Product/Process Change Notice (PCN)

PCN #: WL-SWTC_20171215

WL-SWTC 158353xxx all products

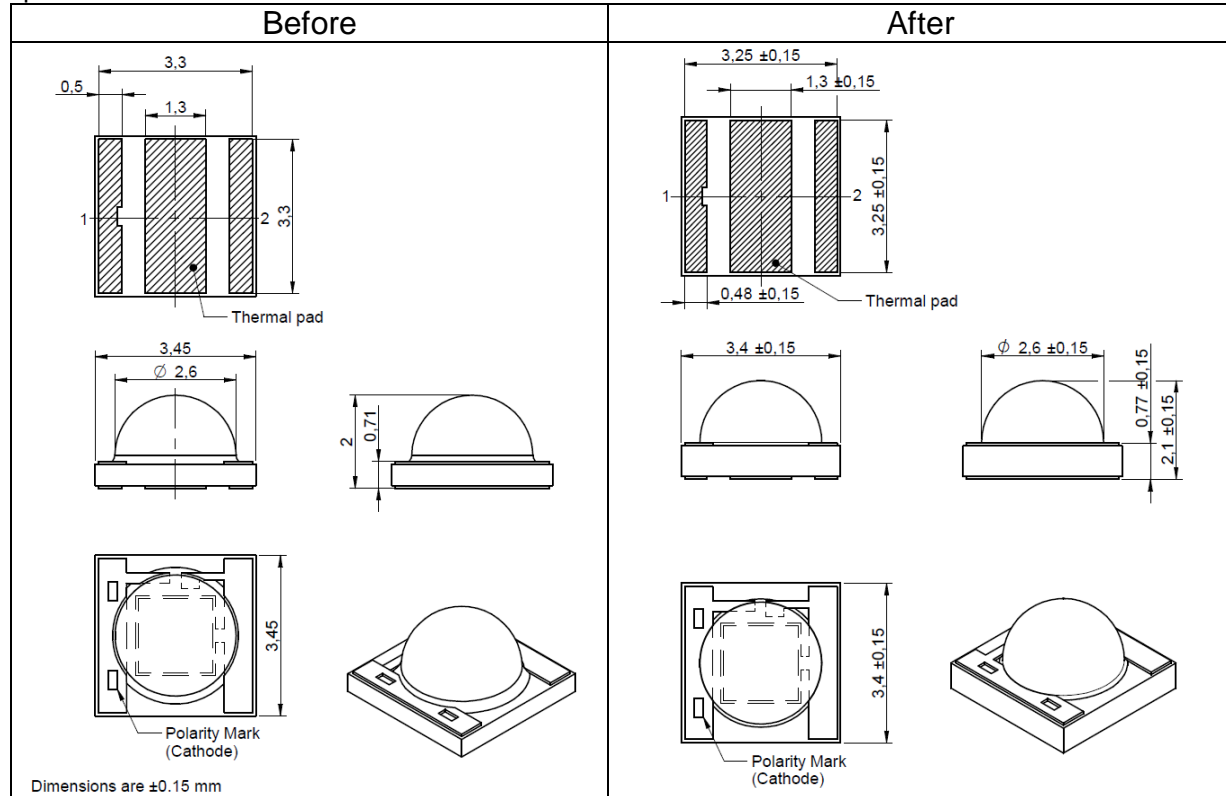
For process improvement purposes, Würth Elektronik will change the dimensions of the substrate for the WL-SWTC line products with 0.05mm

The substrate size will be the only change. The change will not affect the land pattern and soldering specification.
